model number 18	bulletin number 69-01/18-1	date
for serial numbers	to	
subject REPLACEMENT OF DIODES IN 12 VOLT SUPPLY

model number 18	bulletin number 69-2/18-2	date
for serial numbers		to
subject REPLACEMENT OF REFERENCE DIODES IN POWER AMPLIFIER.

model number 18	bulletin number 69-3/18-3	date
for serial numbers		to
subject MODIFICATION OF STEREO PHOTOSWITCH

SERVICE BULLETIN

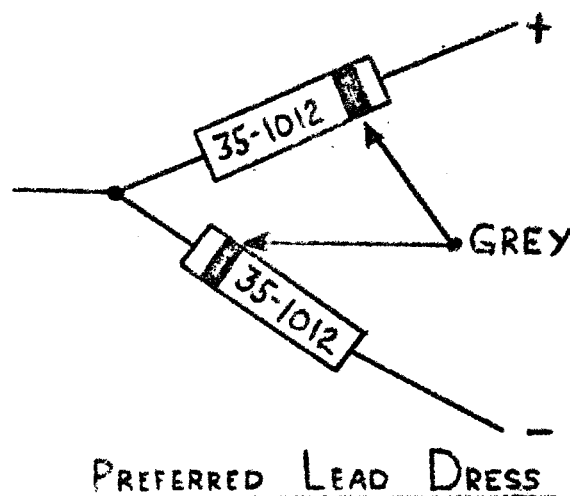
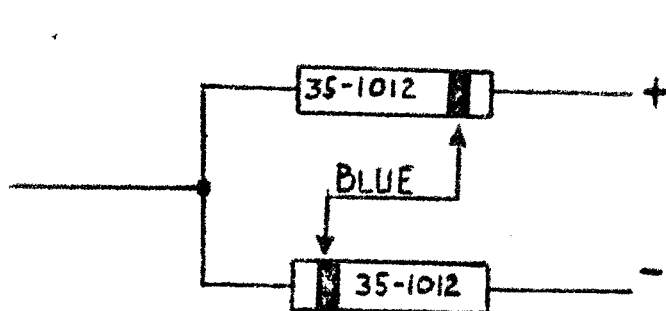
For improved reliability and performance the two Zener Diodes (CR-10 & CR-11) are being replaced by a new type. These diodes are located behind the power transformer on the top main chassis. They provide regulation for the FM sections, scope display and tone amplifier. Their failure will result in a loss of FM operation, scope display or if the fault is in the plus side of the 12V supply (CR-10) it will cause a loss of output on both channels.

The older type, to be replaced, is identified by a blue band. Its leads will be dressed at right angles. the NEW TYPE is identified by a GREY band. This is illustrated below with a drawing showing the old and the preferred new installation.

The part number for the diodes remains the same: 35-1012

FIGURE I:
MR9-054d

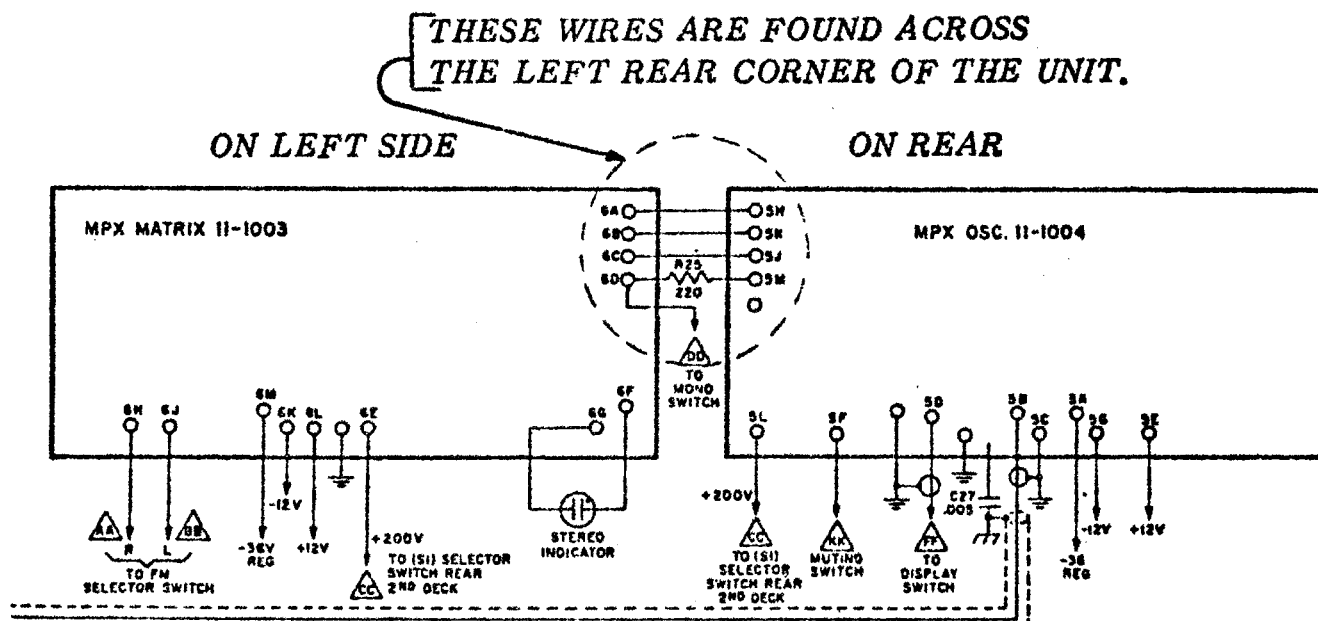
The following circuit modification is designed to correct the intermittent stereo operation in the FM mode which results from improper operation of the STEREO PHOTOSWITCH, LDR602.

1. REMOVE the three wires between the terminals of the MPX MATRIX board and the MPX OSCILLATOR board (See FIG.1). Also remove one side of resistor R-25.
2. REMOVE the two screws which secure the MPX Matrix board to the main chassis. Carefully pull the board away to expose the foil side.
3. INSTALL two insulated wire JUMPERS across both sides of the STEREO PHOTOSWITCH, LDR602 as shown in FIG.2. This effectively bypasses its operation.
4. REPLACE the matrix board on the chassis and re-solder the wires and resistor removed in step one above.

NOTE: IF THE PREVIOUS WIRES WERE SOLID, REPLACE THEM WITH STRANDED WIRE FOR GREATER FLEXIBILITY.

Replacement
LIGHT CELL ASSEMBLY, LDR501
P/N 331-1005-000

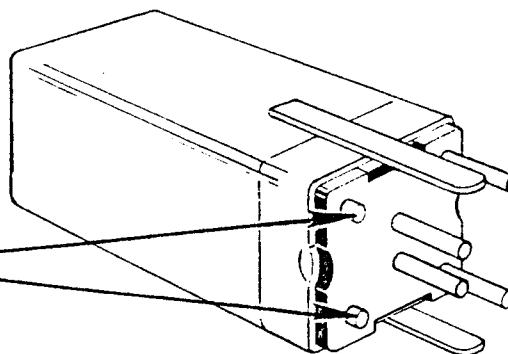
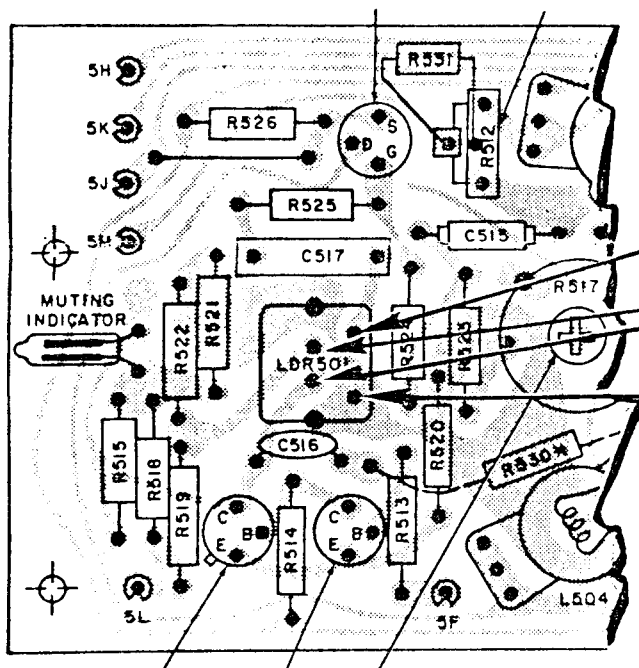
The original LIGHT CELL ASSEMBLY, Ref. Desig. LDR501, Part Number 11-1010 is no longer available and has been replaced by Part Number 331-1005-000.

Prior to installation it is necessary to modify the replacement Light Cell Assembly and the Model 18 MPX Oscillator Board as described below;

Cut (2) Leads

Enlarge PCB Holes
[to accomodate larger
lead diameter of replace-
ment LDR501]
